# Intel Technical Advisory

TA-1031-01

## Intel® Workstation System P4304CR2LFJN may have incorrect system fan bracket installed

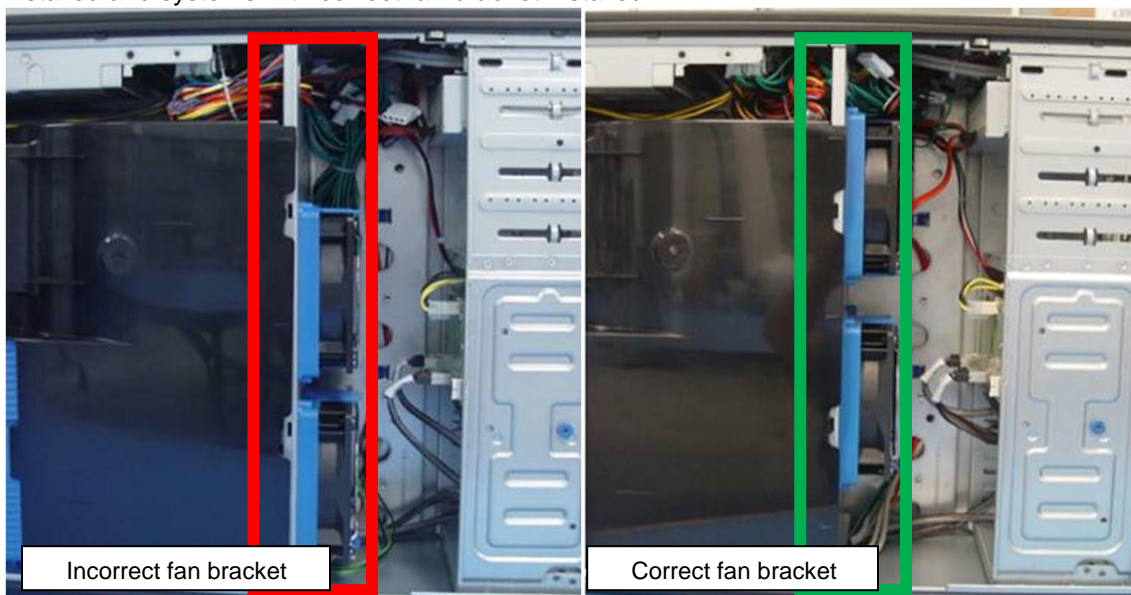
An issue was discovered by Intel for which a small number of recently built Intel® Workstation system P4304CR2LFJN may have the wrong system fan bracket installed (inside). The expected part in the Intel® Workstation system P4304CR2LFJN is a P4000L based fan bracket, but the units affected by this Technical Advisory were configured with a P4000M based fan bracket. The following picture shows the difference between systems with incorrect fan bracket installed and systems with correct fan bracket installed.

The units affected by this Technical Advisory may have incorrect system fan location which leads to relatively higher system fan speed thus worse acoustic performance than the units with correct system fan bracket.

There was an excursion during manufacturing and the Intel® Workstation system P4304CR2LFJN was built with the incorrect system fan bracket.

Short term corrective action: Intel will provide replacement system fan brackets to customers requesting them,

Long term corrective action: An additional fan bracket verification process was put in place in manufacturing to ensure there are no reoccurrences in future.
